Product Update

DENSO® Spark Plug Modifications

Effective Immediately also for Spark Plug Types GI3-3 and GL3-3

Direct Comparison of the Electrodes

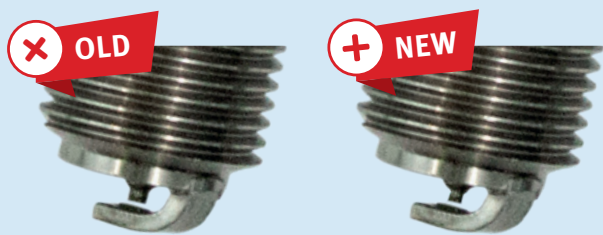
The latest improvement is a change to the material composition of the alloy used for the centre electrode chip. DENSO®'s new patented alloy allows a reduced diameter centre electrode, which results in consistent or improved operating lifetimes. The changes will also enable better management of future fluctuations in the market of precious metals.

With immediate effect, the new alloy is also used for spark plug types GI3-3 and GL3-3. If any of your open order is affected, you will receive a new order confirmation showing the new part numbers as following:

Direct Comparison of the Description

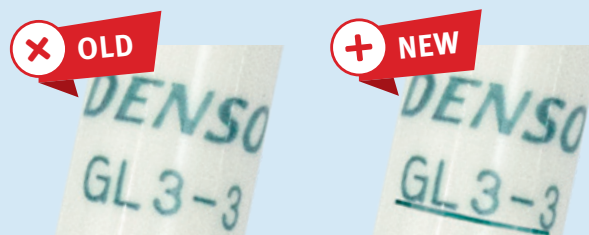
To distinguish the new Spark Plugs from the current range, an underscore has been added to the Spark Plugs description as shown in the photo.

P/N – Old Version	P/N – New Version
GI3-3	GI3-3-267600-0330
GL3-3	GL3-3-267600-0370
